From:	Steve Morris [smorris@giant.com]
Sent:	Wednesday, January 25, 2006 3:44 PM
To:	Monzeglio, Hope, NMENV
Subject:	RE: OAPIS SKETCH

-----Original Message-----
From: Steve Morris [mailto:smorris@giant.com]
Sent: Wednesday, January 25, 2006 1:57 PM
To: Monzeglio, Hope, NMENV
Subject: OAPIS SKETCH

Dwg. 012506
Jan. 25th, 2006
S.C. Morris

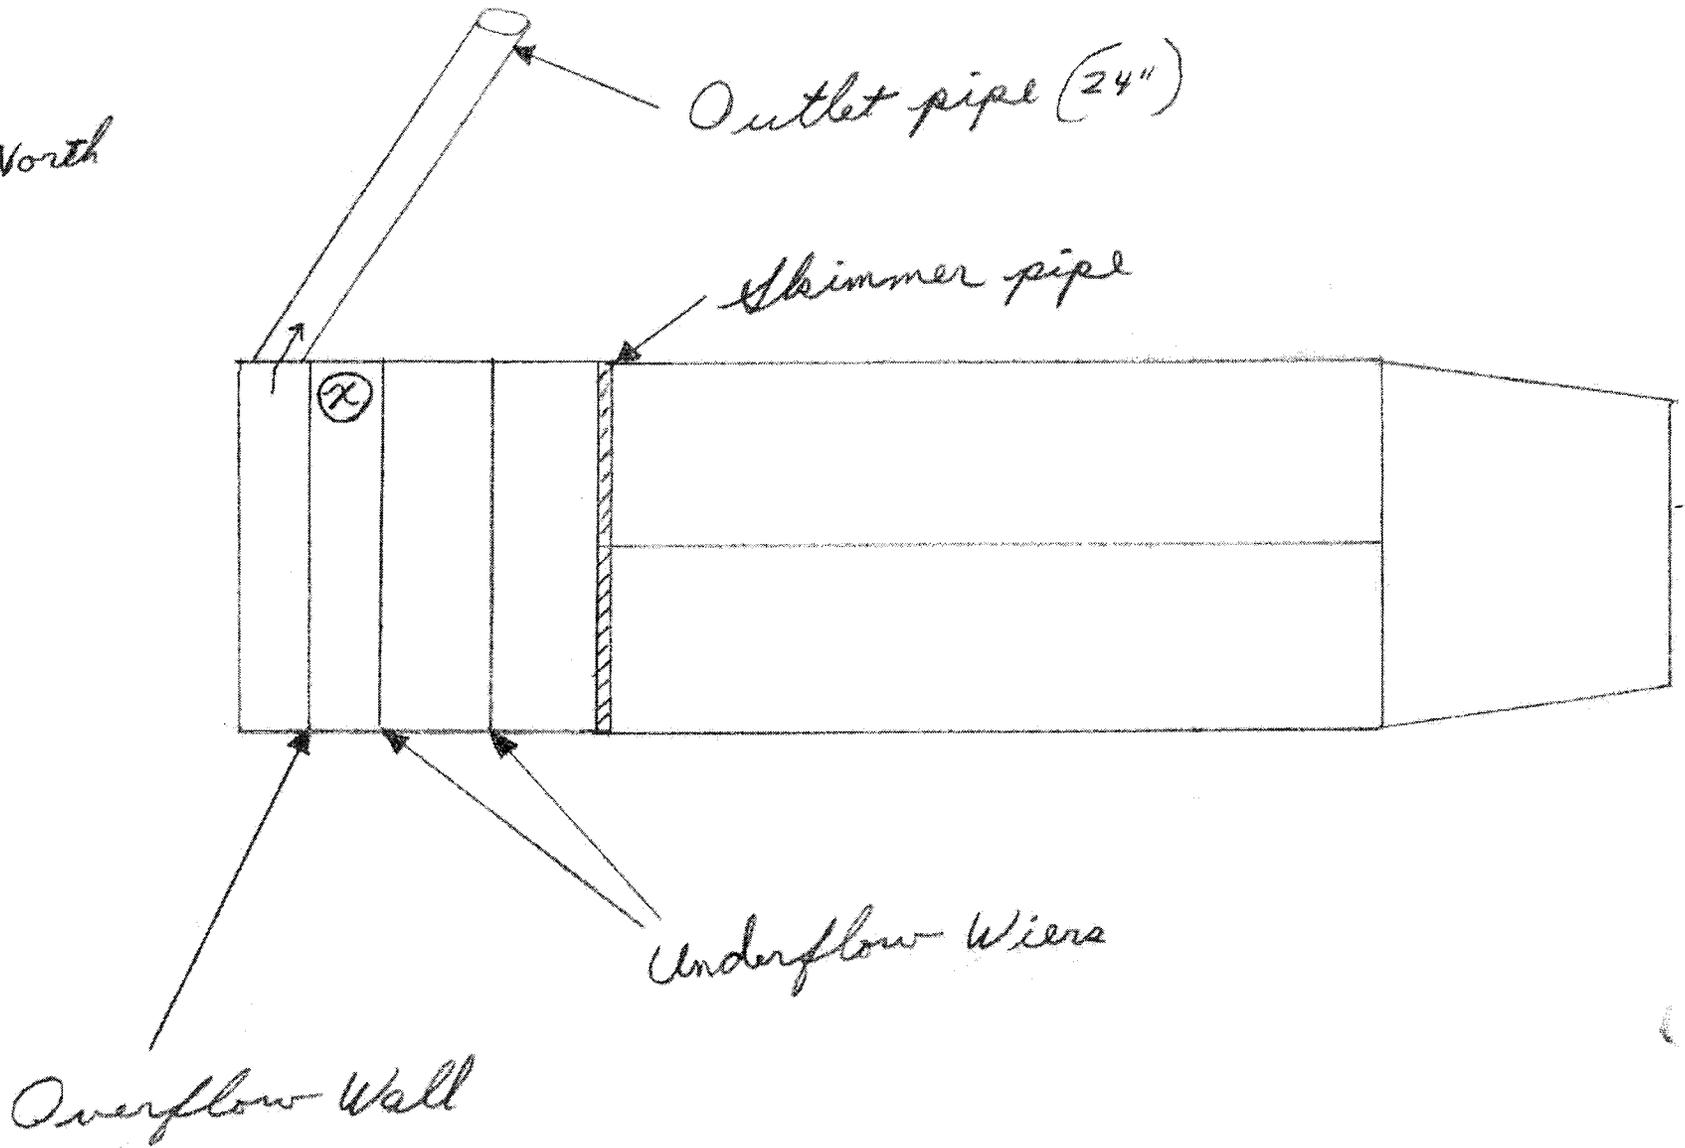
Thanks for the sketch. I figure email may be easier since we keep playing phone tag. I
have questions on how you are collecting the effluent sample.

1. When you collect a sample for from the Old API separator are you taking a surface
sample or scooping water from within the separator for a sample?

2. To clarify, the last few sampling events, was the sample collected from a point where
effluent was flowing or trickling out of the Old API or from within the separator as
stated in #1?

3. When you have a storm water event and you have effluent flowing out, are you able to
obtain a sample from the flowing effluent coming out of the Old API or do you collect the
sample from within the Old API?

I was not sure if there was a sample port at the X on the sketch. If you need
clarification let me know.

Hope,
I have been taking a clean empty 1 gallon distilled water bottle and dunking it in to the
last portion of the water section of the OAPIS. As it is filled, I do get surface water.
Once the gallon bottle is full, I fill the sample bottles right away.

The small trickle of water flows from the south side of the water section and I have been
catching the sample on the north.
The reason for that is that it is easier to reach the water from that side.
I can, however, catch samples from right where the water exits the water section. (no
problem)

During a storm event I could catch a sample of the water as it enters or exits the drain
pipe.
The snow we got today didn't amount to enough moisture to see a difference at the OAPIS.
Hopefully we will get more tonight.
If we do, would you like for me to catch a sample as it enters lagoon #1?
Let me know if this helps.
Thanx, Steve.
